Ehsan Garments Moonlight Garments Ltd

Kuniapachar, Targach, Gazipur, Dhaka
(+23.928808N, 90.389160E)

25 September 2013

Updates to Structural Drawings Required

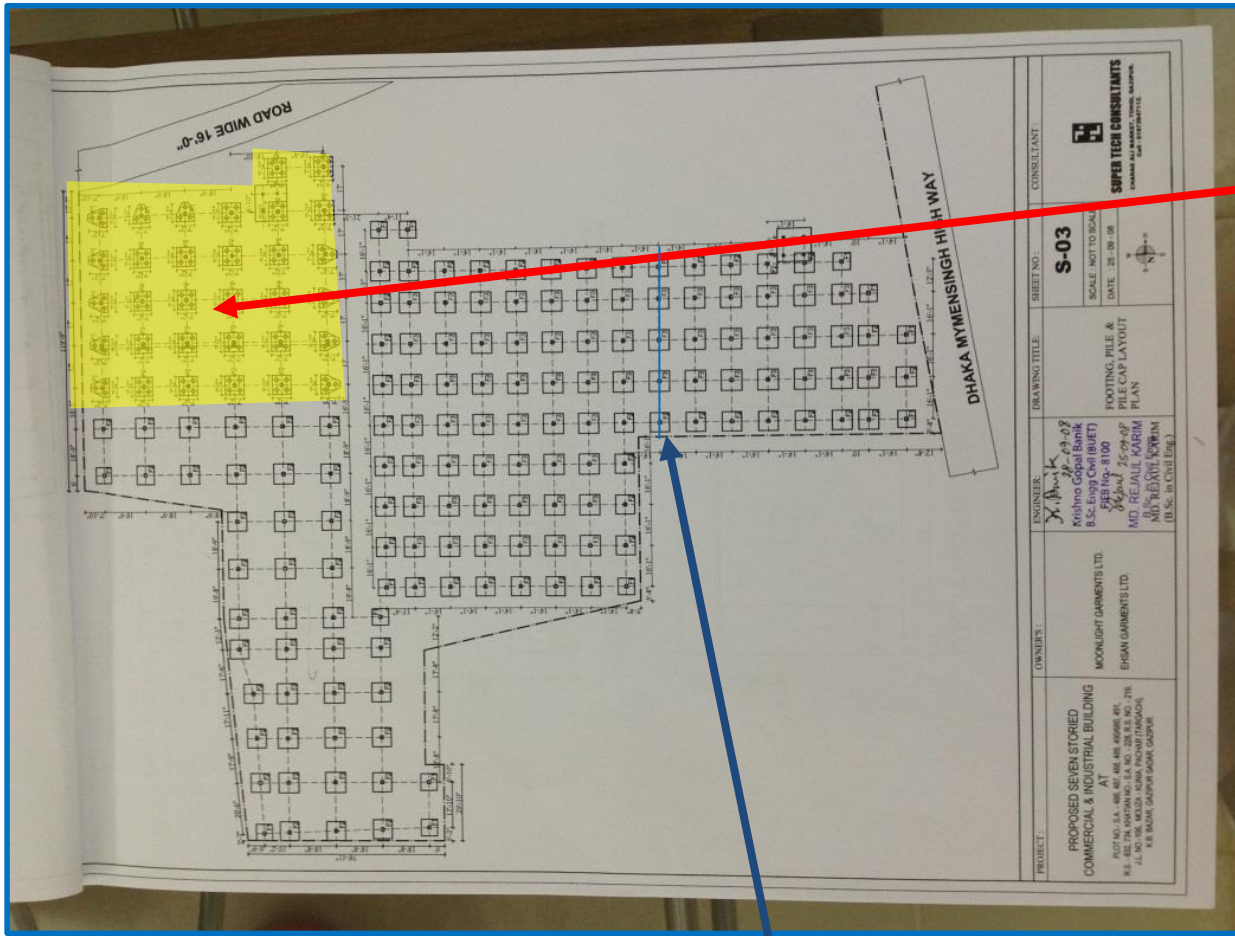
Local column spacing on structural drawings does not match the as constructed condition

5th & 6th floors are of flat slab construction. Other floor are beam & slab.

Approx location of building movement joint

Relative movement at floor slab movement joint within the East Factory.

Building Engineer to review implications of deviations from structural drawings.

Updates Required to Structural Drawings to reflect as-constructed structure

Building Engineer to review flat slab design and advise allowable floor loading.

Collate Ground Investigation Information
